From: Drummond, Jaclynne
To: "jblanchard@harnett.org";
cc: "ryan@ctclayton.com"; Hammonds, Andrew; Shackelford, Dennis;
Subject: RE: Dunn-Erwin Landfill Phased Assessment Plan 43-07T - Follow Up
Date: Monday, November 09, 2009 12:37:00 PM
Attachments: 1983 Aerial Exhibit.pdf

From: Drummond, Jaclynne [mailto:jaclynne.drummond@ncdenr.gov]
Sent: Monday, October 19, 2009 2:38 PM
To: jblanchard@harnett.org
Cc: ryan@ctclayton.com; Hammonds, Andrew
Subject: Dunn-Erwin Landfill Phased Assessment Plan 43-07T - Follow Up

ORTHOPHOTO MAP OF HARNETT COUNTY, NORTH CAR

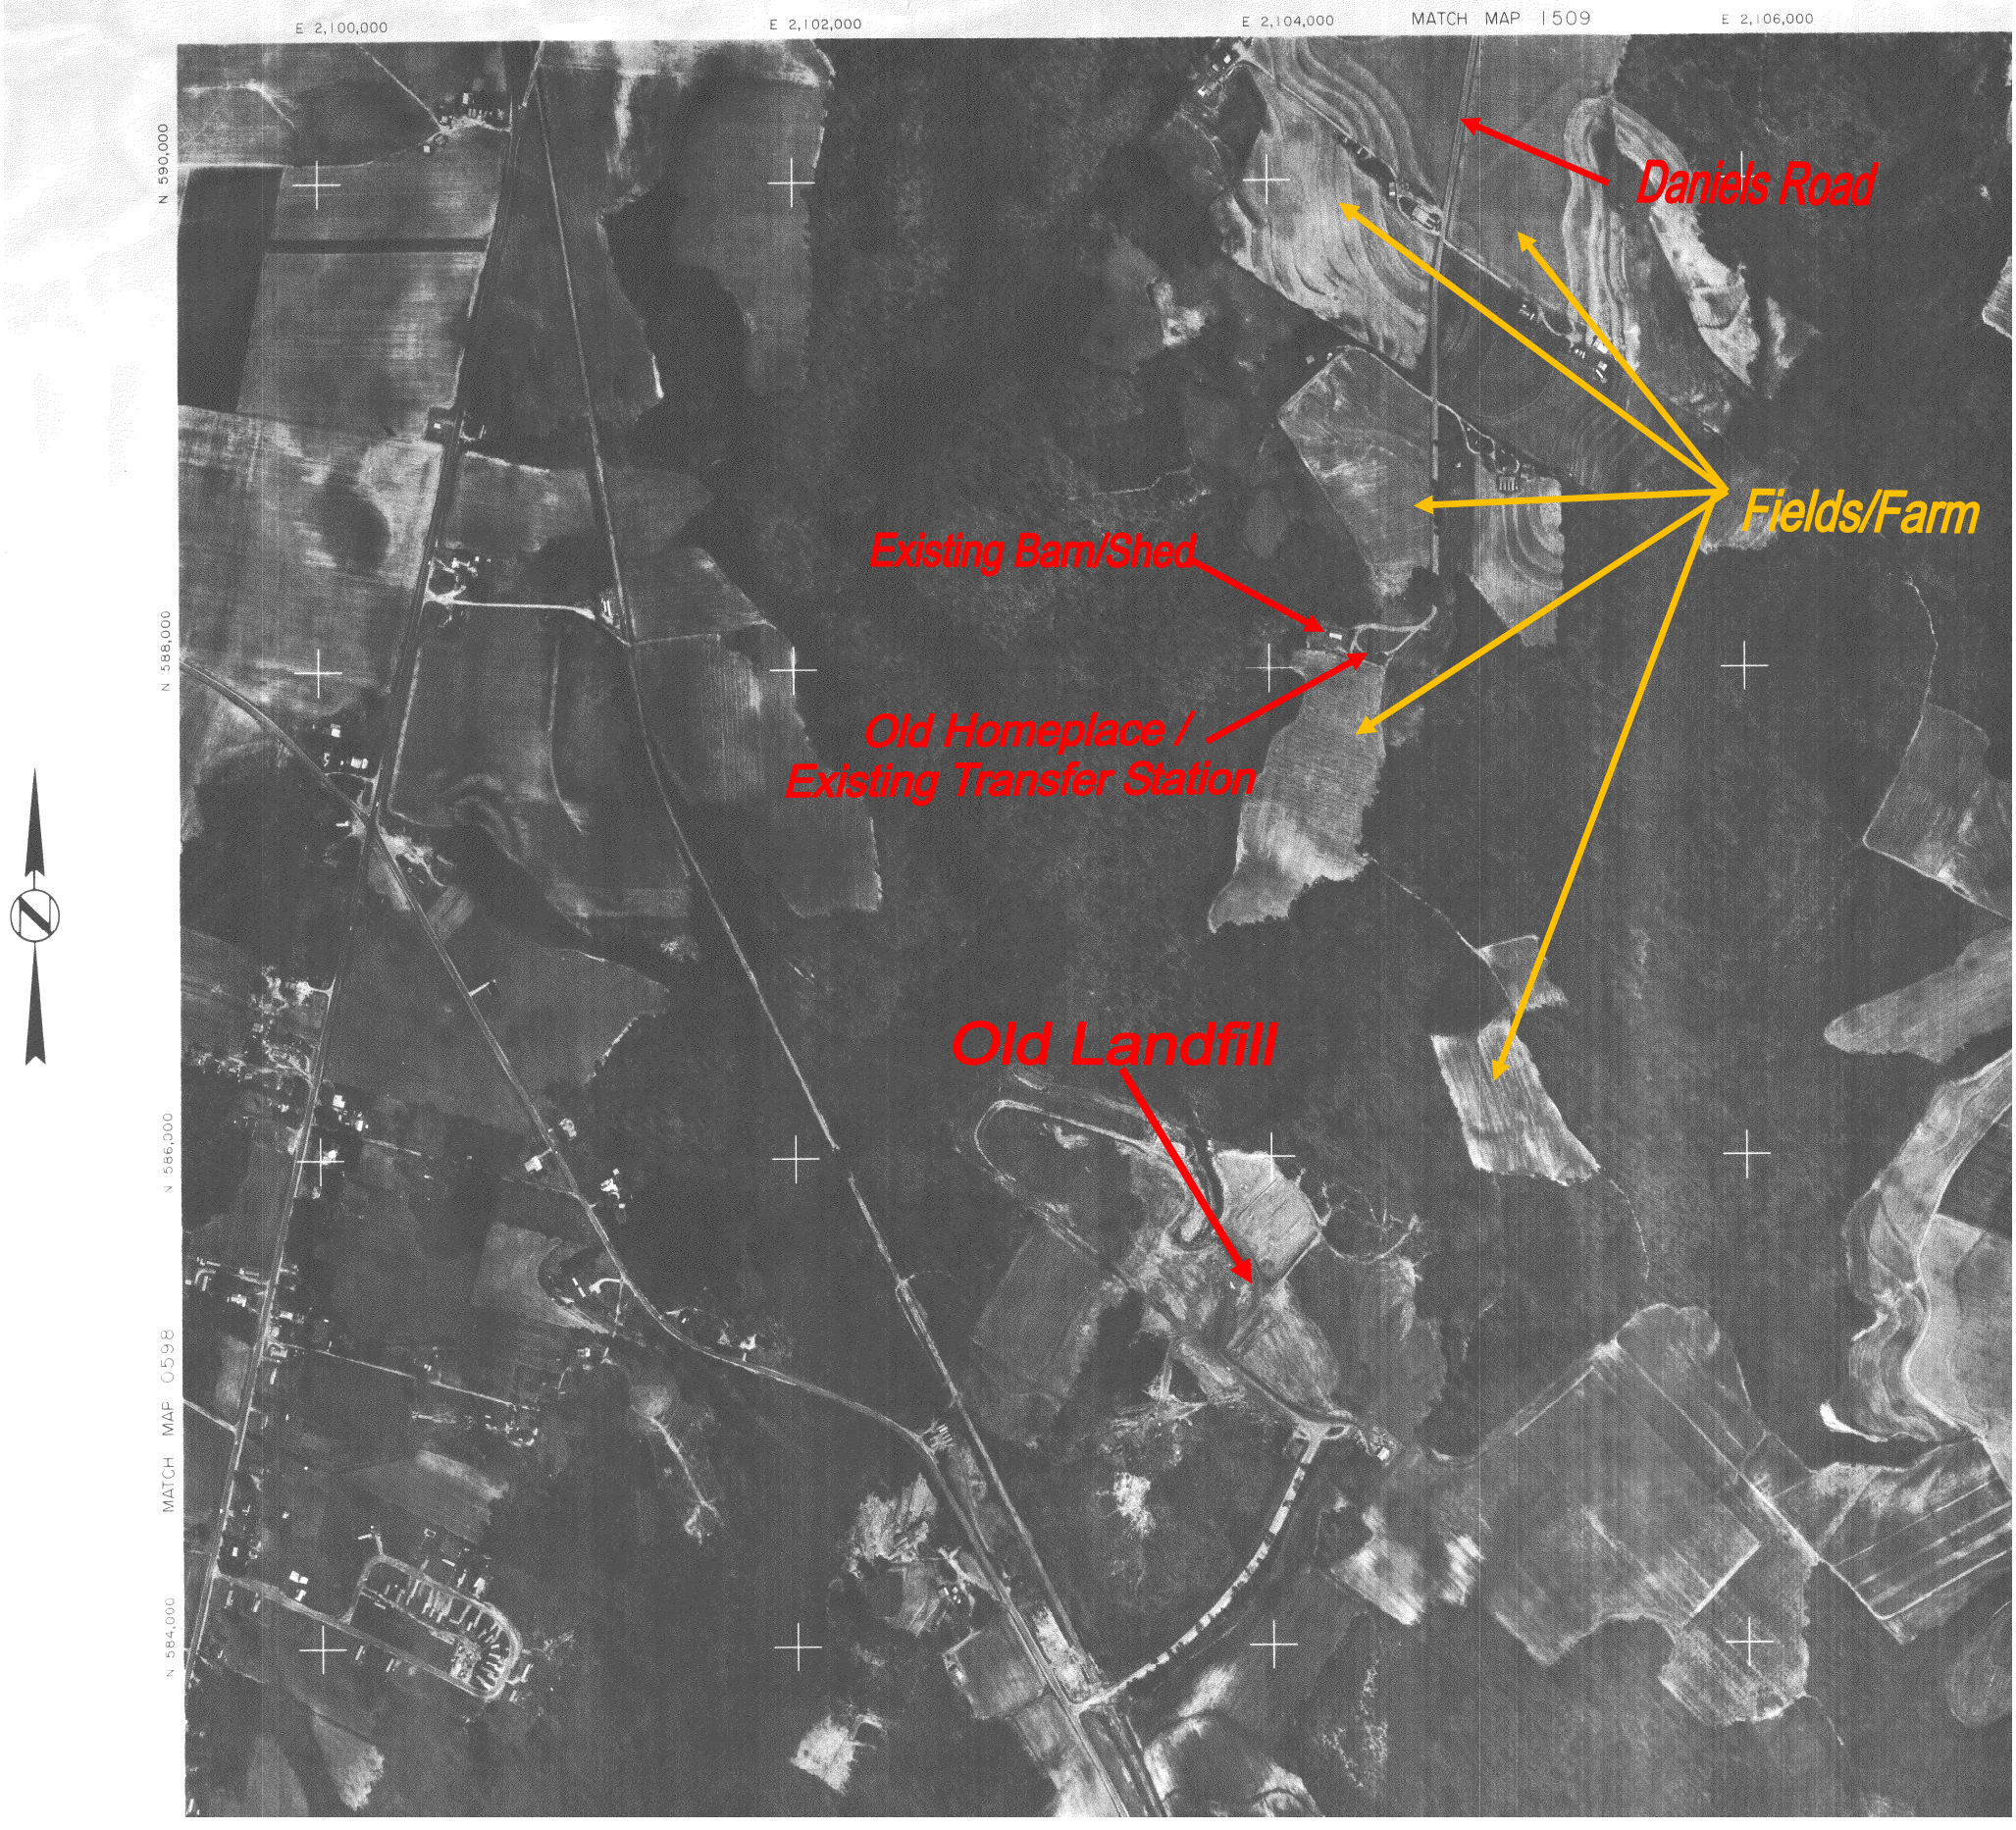
Jackie,
We have researched the history of the site and have found what we believe is the source of the elevated phosphorous levels for this area. The leachate tanks (source of the spill) are located just a few feet in front of the old (still existing) tractor/storage shed for the old farming homeplace which was utilized up until approximately 1992. This farming operations barn/shed would have been used for storage of fertilizer and as a tractor storage/loading area which would have leached fertilizers continually over the years into the ground surrounding the shed.

The upgradiant sample should not have come into contact with any leachate source or spill and therefore we do not believe the high phosphorous levels are leachate related. However, the upgradient sample is in close proximity to the shed and would have been in the area used for tractor loading and storage.

The attached aerial dated 1983 shows the location of the shed, homeplace, and the old Dunn-Erwin Landfill. Please call with questions or comments.
Thanks,
Ryan Sadler
C.T. Clayton, Sr., P.E., Inc.

Jerry,
I have reviewed the October 26, 2009 email response submitted by Ryan Sadler (with CT Clayton, Sr, PE, Inc.) along with the attached 1983 orthophoto map of the facility. Based upon the email response (alternate source demonstration), the 1983 orthophoto map, and the soil analytical results from the *Dunn-Erwin Landfill Phased Assessment Plan – Follow Up* for 43-07T dated October 12, 2009, there appears to be no residual contamination within the soils from the leachate release at this time. However, the Solid Waste Section recommends establishing a grass cover in the areas where the phosphorus concentrations were elevated if a grass cover is not already established (the photos located within the August 11, 2009 *Phased Assessment Plan* showed sparse grass cover in these areas). The growing grass cover should assist in the uptake of the phosphorus from the soils. After established, the grass cover in these areas should then be mowed and the grass cuttings removed to stop the accumulation of the phosphorus within the soils. If you have any additional questions or concerns regarding this correspondence, please feel free to contact me.
